Access Compliance Report

Public Rights-of-Way

Intersection ID: 53014	Main Street: ACADEMY_ST	Cross Street: CHARTRES_LN	Location: NE
ADA ID: ACDAF614B7F4	Ramp Type: BlendTrans1	Initial Pass/Fail: Pass	Overall Compliance: No
		Severity Score: 10

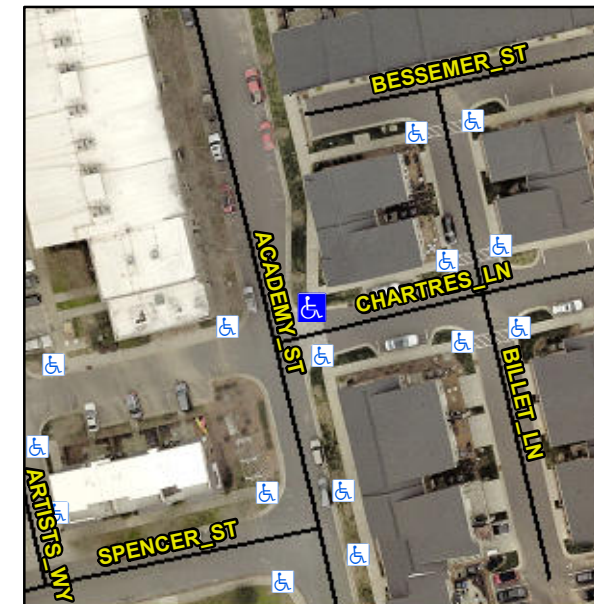
R304.2.2-Perp, R304.3.2-Para, R304.5.3, R305

Remove & Replace Curb Ramp With Two New Directional Ramps or Equivalent. Remove & Replace Gutter.
